# Field Service Bulletin

FSB 18-04-16-01 REV18-04-019

**Date:** April 16, 2018 **REVISION April 19, 2018****Subject File:** 2018 Kenworth and Peterbilt – ECM Issues**Product:** ECM Telemetry Causing Issues – Applies to all Locators and GPS Boxes and Cable – WT0147 VIC J1939 Type 2 Threaded (SKU: 03-09-0226-00.1)**Author:** Richard McIntyre <Richard.McIntyre@bsmtechnologies.com>

### WT0147 (J1939 Type 2 Threaded)

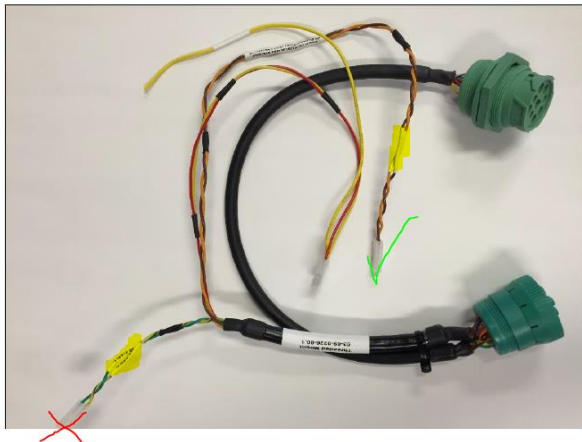
On 2018+ Kenworth and Peterbilt. CONNECT the **VIC's** ECM pair labeled **Pin F** and **Pin G**, the orange and brown ECM pair.

**Do NOT connect to pins C&D** (High Speed CAN BUS) on the Tractors Green Type II J-1939 Deutsche connector (Data Port).

Connecting to the High speed CAN-BUS (pins C&D of the 9 pin Deutsche connector) may cause transmission fault codes that would randomly cause the truck to go into limp mode. In addition, odometer is not available of pins C&D.

For all 2018+ Kenworth and Peterbilt that have been connected to date instruct clients that are self installer, to change the connection to ECM pair labeled as **Pin F** and **Pin G** (from it is recommended configure Locator or GPS Box to disable all ECM activity. Inform client in advance if HOS, they'll need to instruct their drivers to go to paper logs. For all clients that are installed by BSM Field Service Team will work through these.
